## **Stage 1 Road Safety Audit**

**Proposed Kellystown Wind Farm, Co Louth**

**On behalf of EDF Renewables Ireland Ltd.**

**August 2025**

##### 3.3.1.2 Public Road Drainage

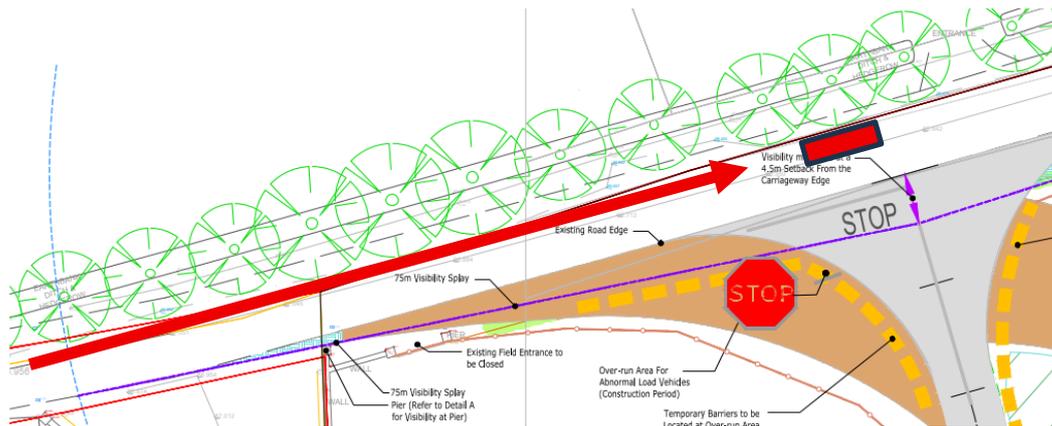
**Problem:** There is a drainage gully located within the mouth of the proposed junction. Slewing of heavy vehicles may dislodge the gully grating or frame.

**Hazard:** Public road traffic may hit the dislodged grating or open gully pot and lose vehicle control.

**Recommendation:** The Design Team should relocate the gully outside of the mouth of the junction. The Design Team should also ensure the works do not result in ponding occurring thin this area.

3.2.1	Yes	Yes		
3.2.2	Yes	Yes		
3.3.1.1	Yes	Yes		
3.3.1.2	Yes	Yes		
3.3.2.1	Yes	Yes		
3.3.2.2	Yes	Yes		
3.3.3.1	Yes	Yes		
3.3.4.1	Yes	Yes	This entrance will no longer be used as part of the development. The recommendation is no longer required.
